NOTICE OF MEETING
PLANNING AND ZONING COMMISSION
6:00 P.M. – February 13, 2020
30360 Cougar Bend, Bulverde, TX 78163

PLANNING AND ZONING COMMISSION ITEM:
PC-20-01
PRELIMINARY PLAT
PRESERVE AT SINGING HILLS, UNIT 5

REVIEW MEMORANDUM

REVIEW MEMORANDUM

SUBDIVISION PLAT ESTABLISHING THE PRESERVE AT SINGING HILLS, UNIT 5

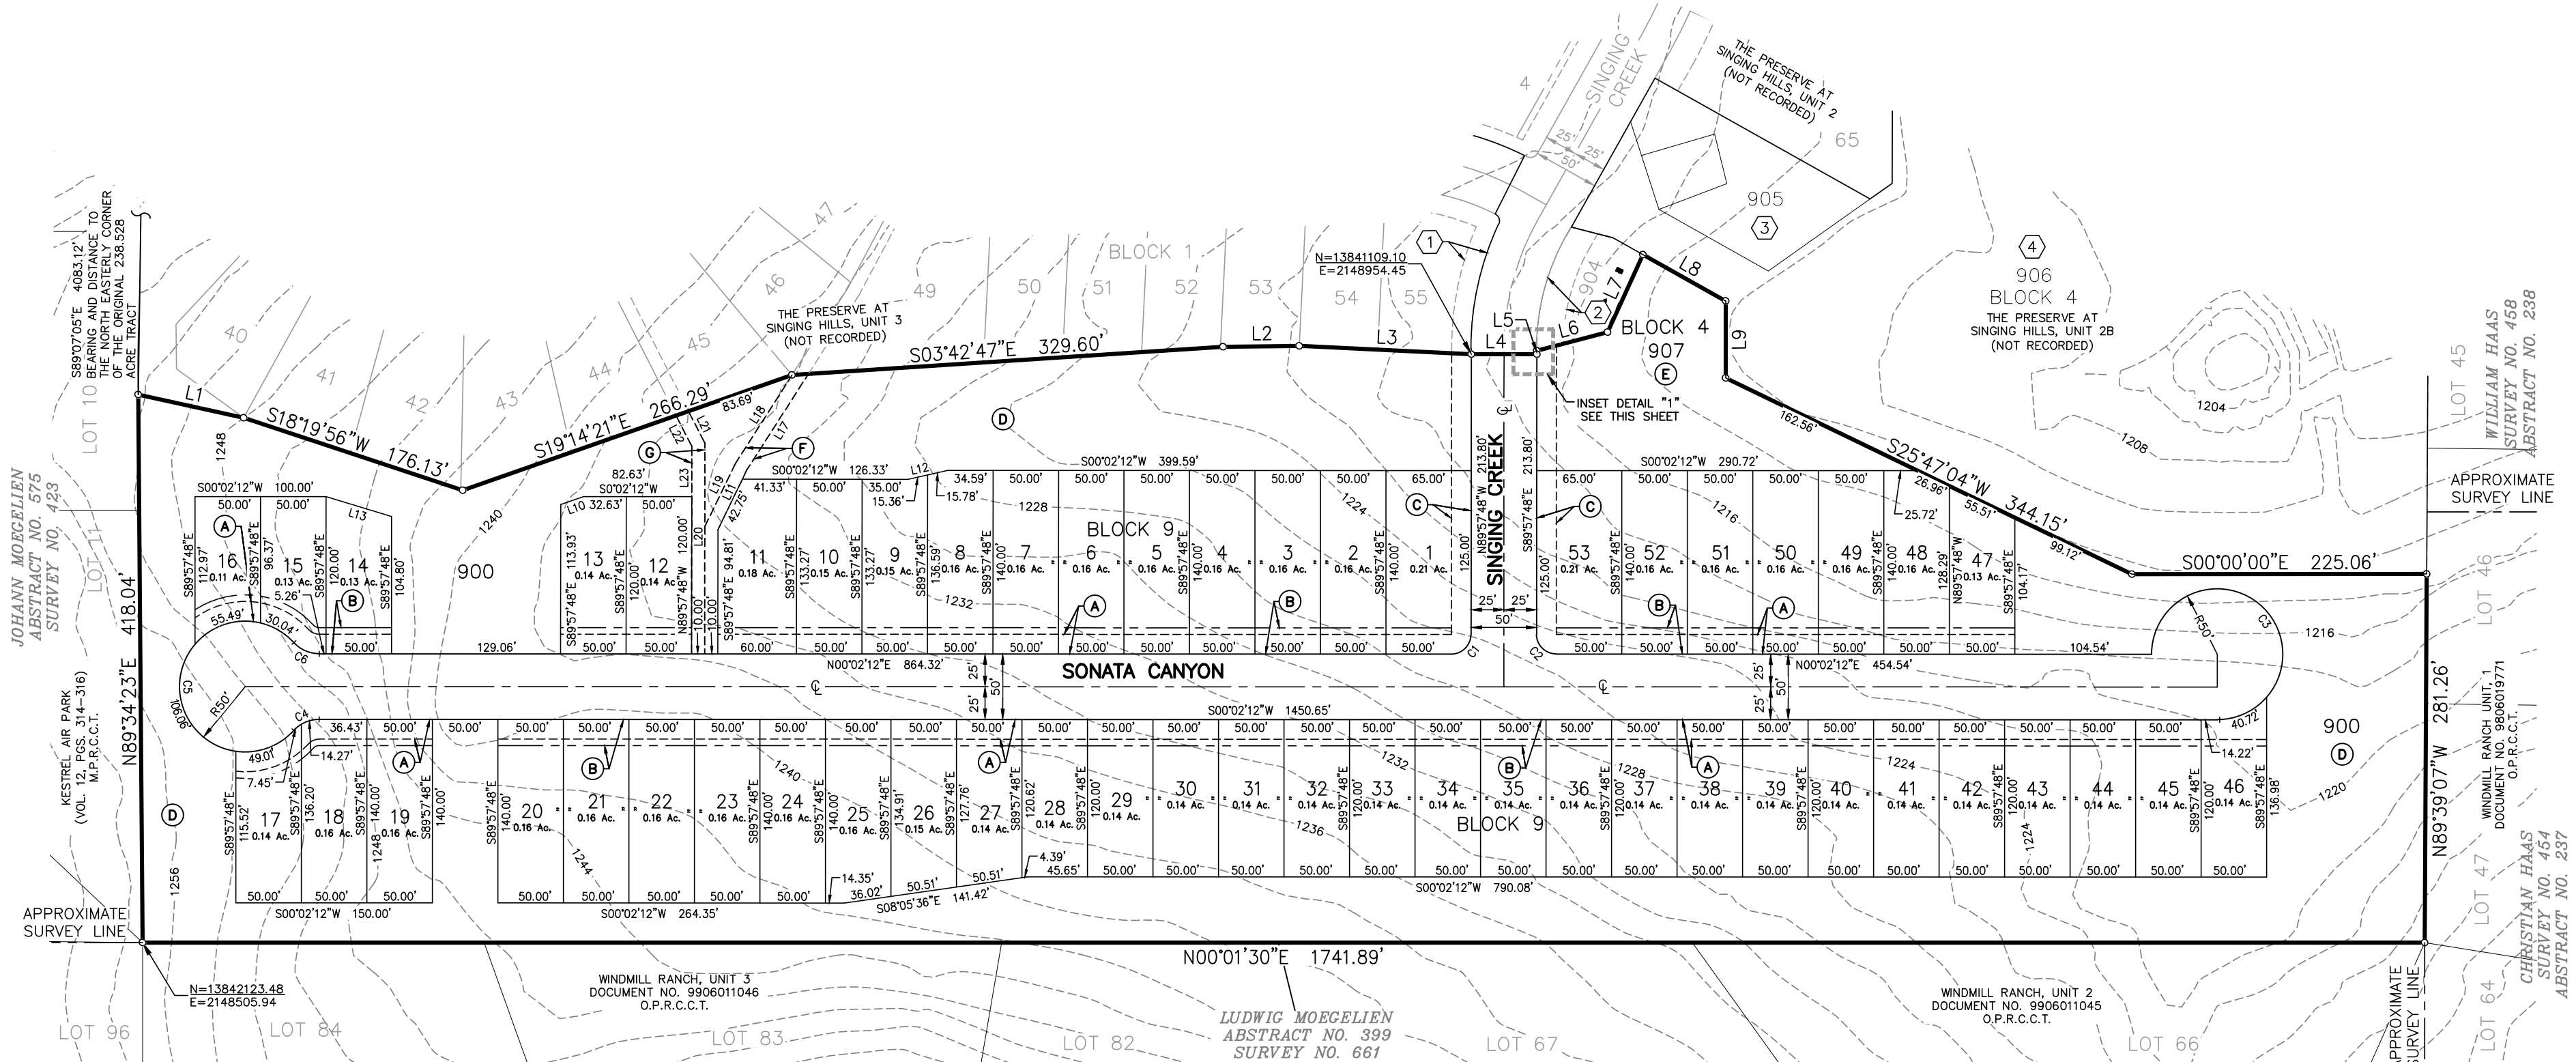
1. Several lots are missing lot #'s – [Comment resolved](#).
2. Each lot needs an acreage callout – [Comment resolved](#).
3. Update subdivision note 1 (preparation date) and 6 (acreage/LF ROW dedication). – [Comment resolved](#).

SUBDIVISION PLAT
JOHNSON RANCH
NORTH - UNIT 9
COMAL COUNTY, TEXAS

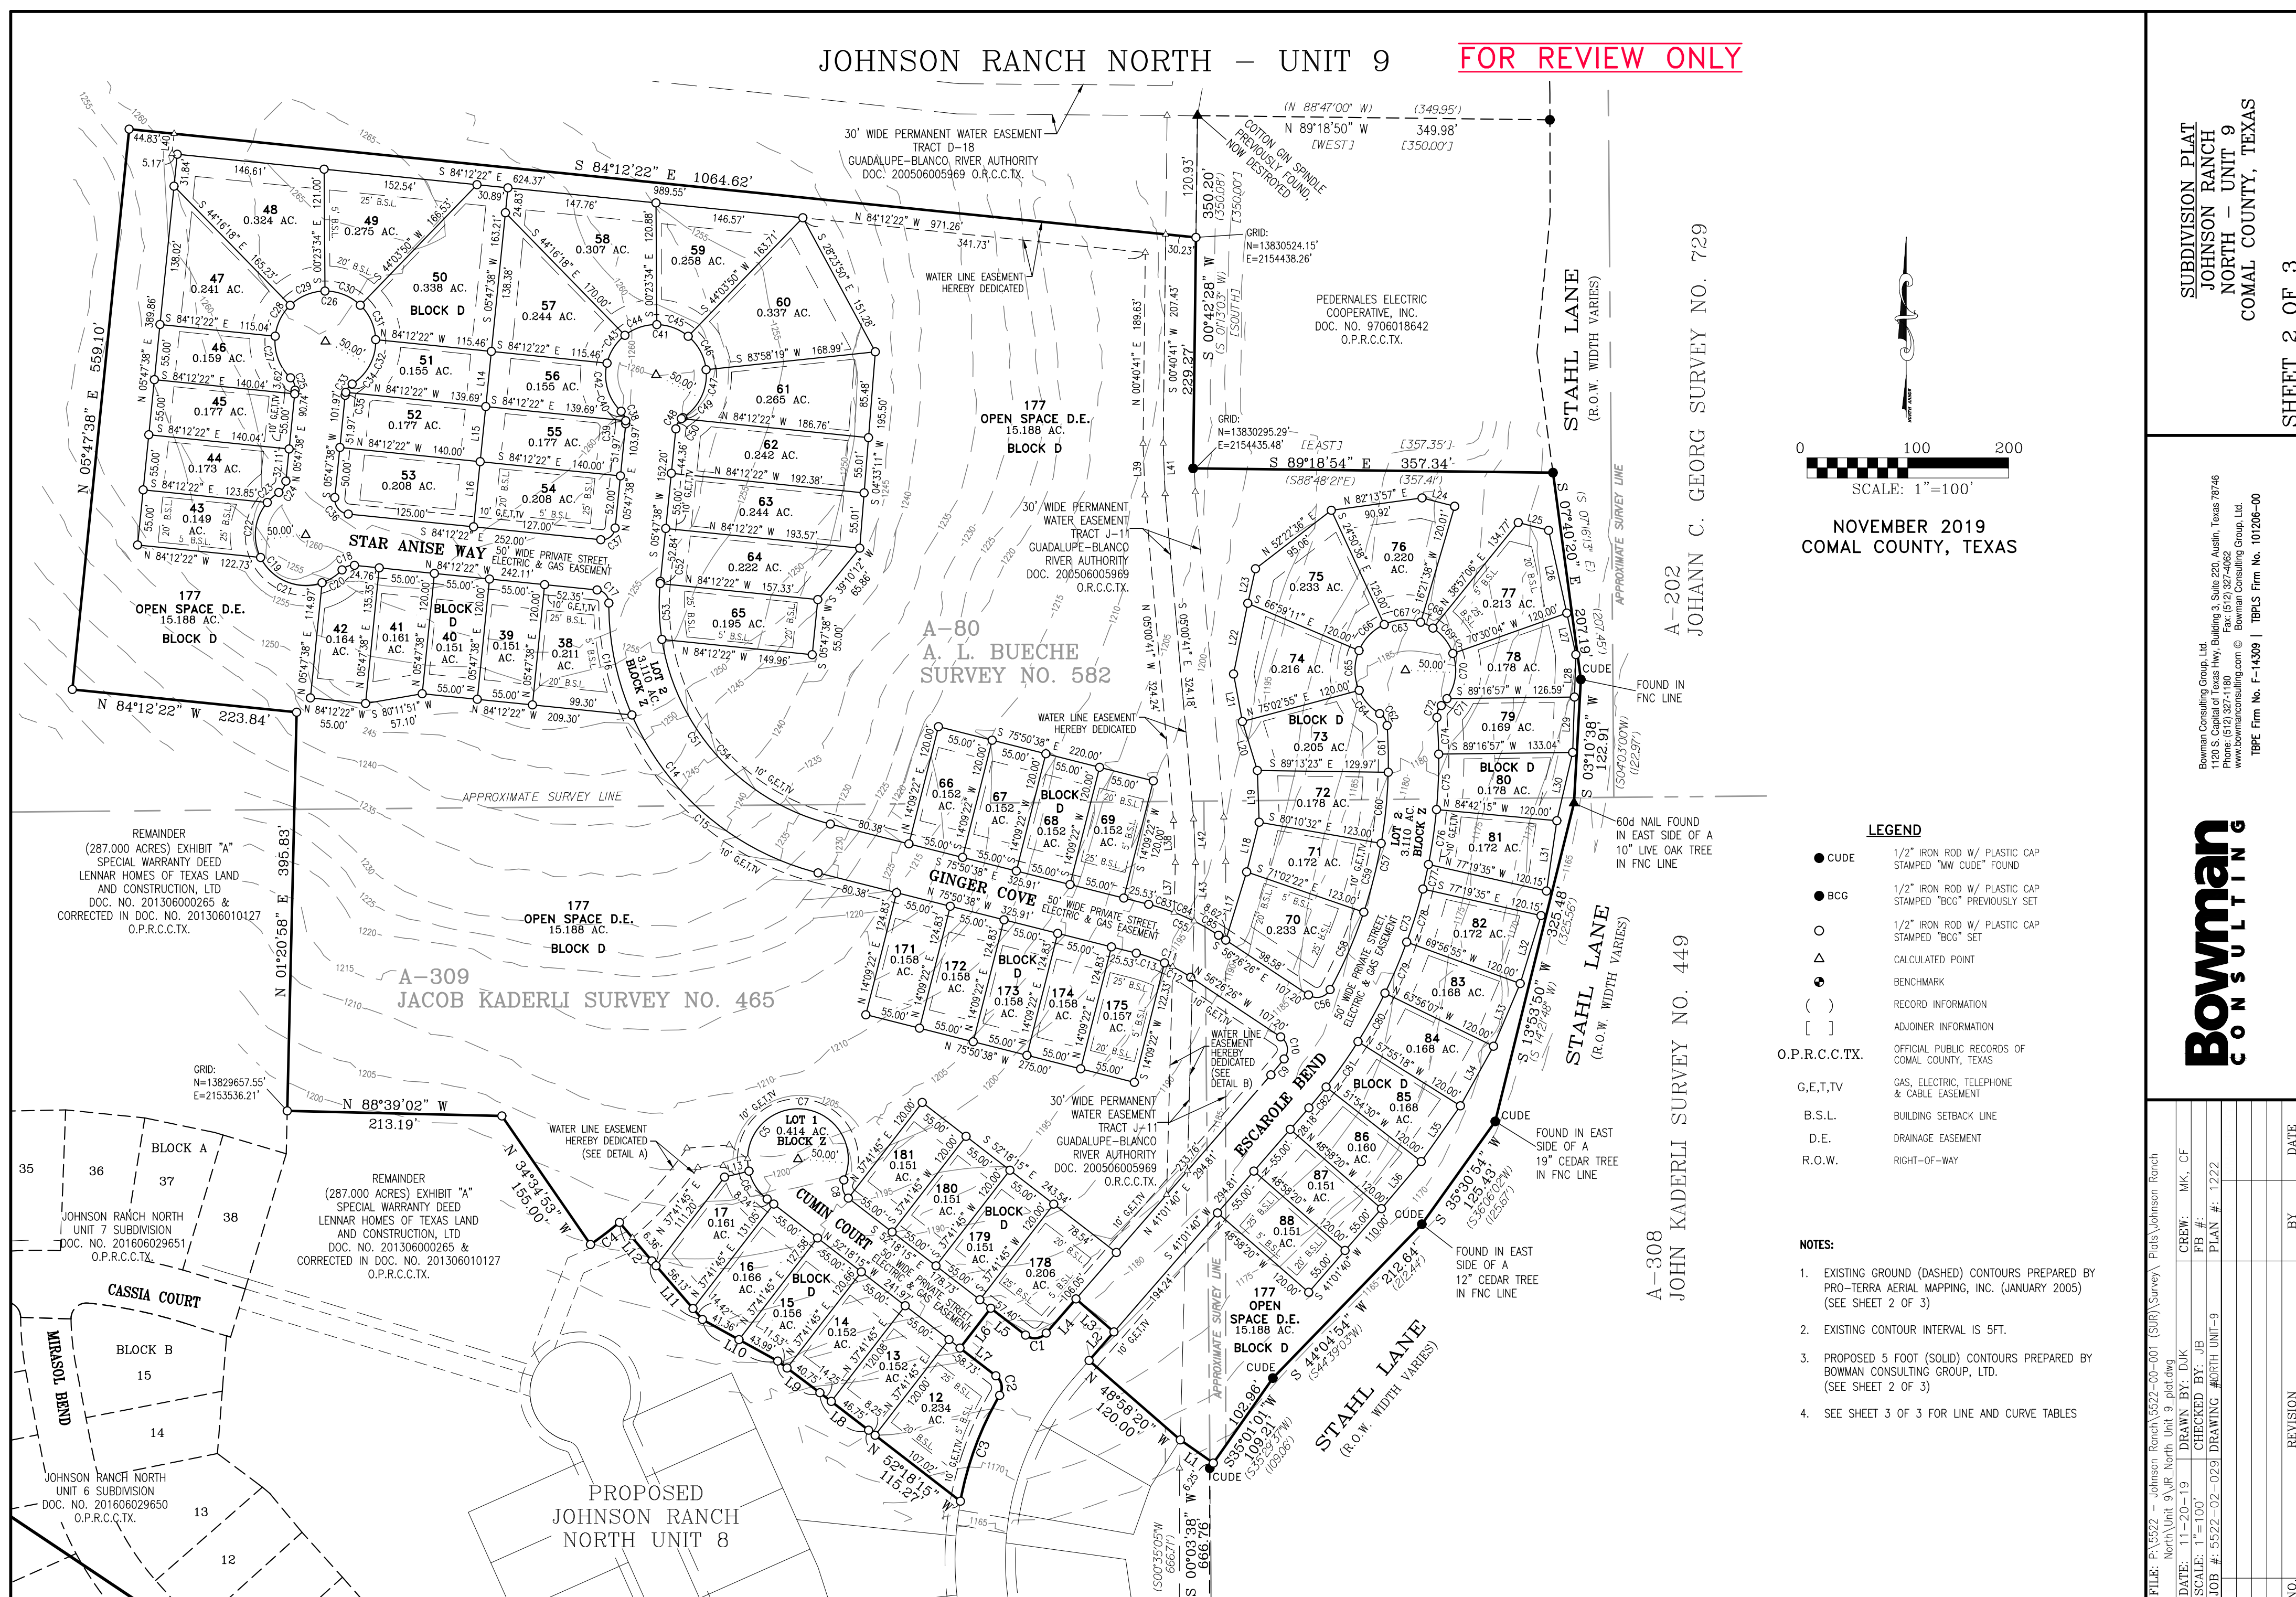
1. Per the City's adopted Transportation Master Plan, Stahl Lane is classified as an arterial roadway (86' ROW). Additional ROW dedication is needed along the eastern property boundary.
2. Developer Agreement Exhibit 'C' – Unit 9 consists of 31.363 acres and 66 residential lots, averaging 1 lot per 20,700 square feet of gross land area. This exceeds the one residential lot per 30,000 square feet allowed. Please provide cumulative calculation of single family lots platted vs. total lots allowed per developer agreement section 3.02.

3. Unit 9 appears to vary from the Master plan acreage and lots.

4. 1.05(b) – Plat indicates only one (1) Block 'D' for all lots. Residential lots are separated by Open Space and as well as front various streets within Unit 9. Additional Blocks should be delegated within Unit 9.
5. 1.05(b) – Provide Bearing and Distance dimension from a corner of the subdivision to a corner of the original tract or original survey.
6. 1.05(b) – Show City limits and limits of City's ETJ on Vicinity Map.
7. Lots 59-64 exceed the "Aspect Ratio" that lots be no greater than 3.5:1 unless approved by City Planning Director or City Engineer. Lot dimensions appear to be within acceptable intent of the Aspect Ratio, therefore no corrective action is recommended. – [No response required.](#)
8. Plat margins are incorrect. Left margin should be 2". Top, right and bottom should be ½"
9. Metes and bounds description of the subdivision property must be included in the plat.
